ST/SG/AC.10/2000/20/Corr.1
4 October 2000

**COMMITTEE OF EXPERTS ON THE TRANSPORT
OF DANGEROUS GOODS**

Draft amendments to the Recommendations on the Transport of Dangerous Goods

**Proposal resulting from the Working Group on classification of ammonium nitrate emulsions,
Intermediate for blasting explosives**

Figure 18.4.4.1: Vented pipe test

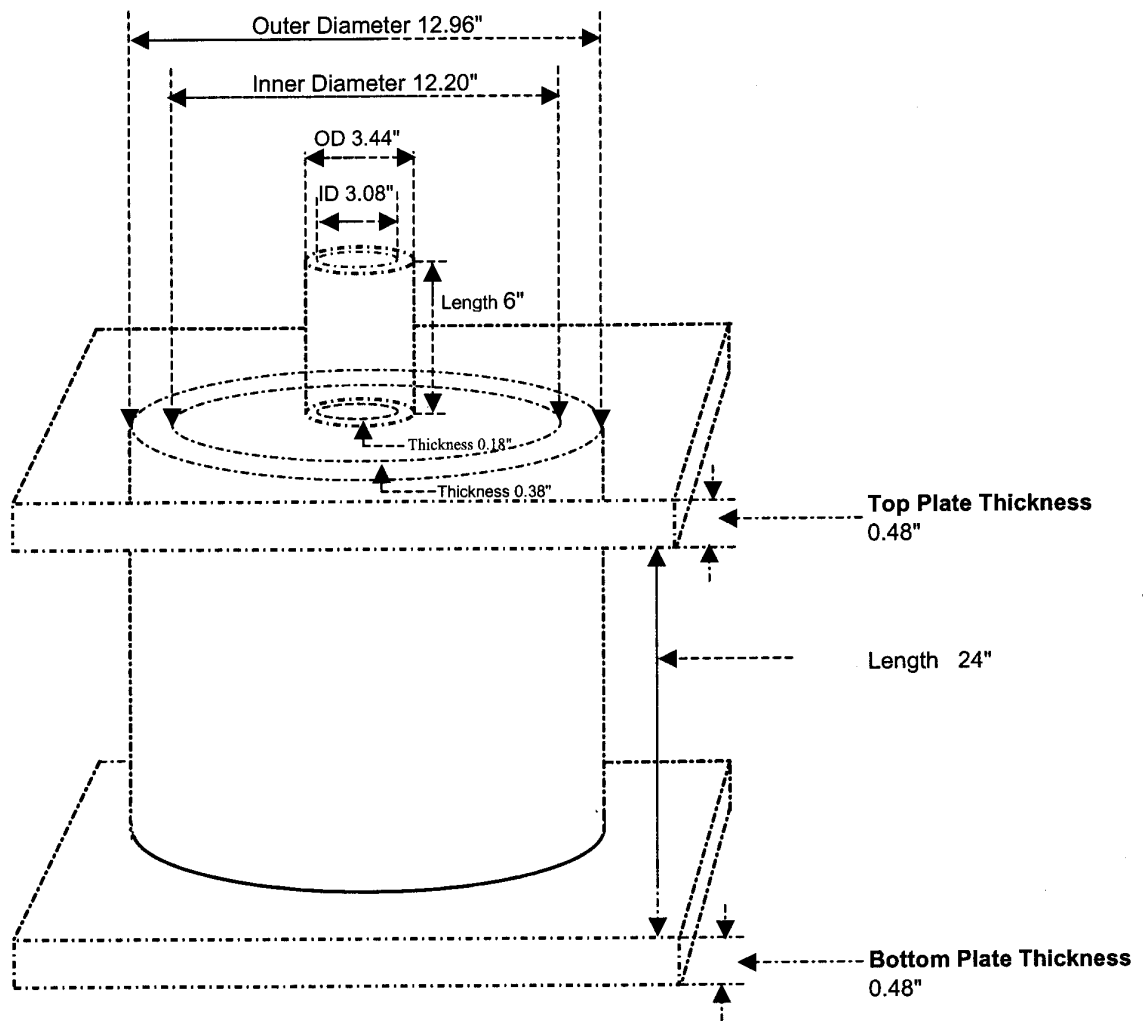
The drawing of Figure 18.4.4.1 - Vented pipe test - should be replaced by the one reproduced below.

Material of the pipe: Schedule 40 c carbon (A53 Grade B) steel
